47X Twinsteer Idler Arm

Field Service Campaign SF689

Published : July 2024

Fig. 1, Removal of the Drag Links

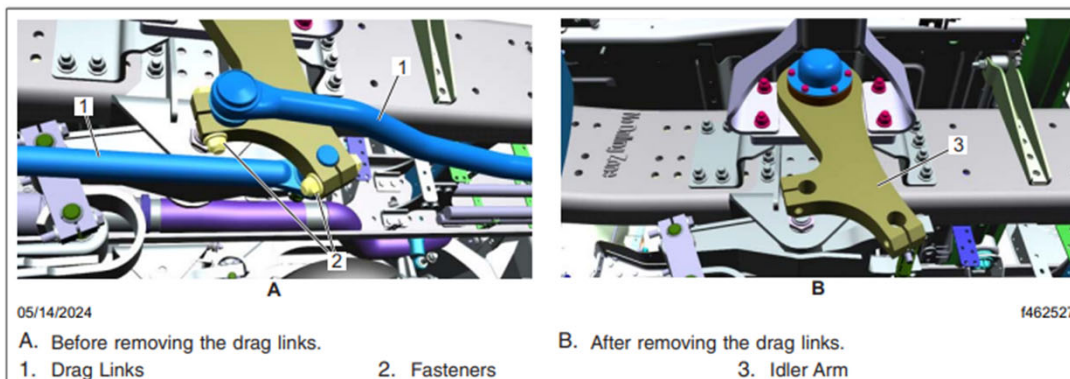
1. Check the base label (Form WAR259) for a completion sticker for SF689 (Form WAR261), indicating this work has been done. The base label is usually located on the passenger-side door, about 12 inches (30 cm) below the door latch. If a completion sticker is present, no work is needed. If a completion sticker is not present, proceed to the next step.
2. Park the vehicle on a level surface, shut down the engine, and set the parking brake. Chock the tires.
3. Remove the idler arm fasteners, and remove both drag links from the idler arm. See [Fig. 1](#).
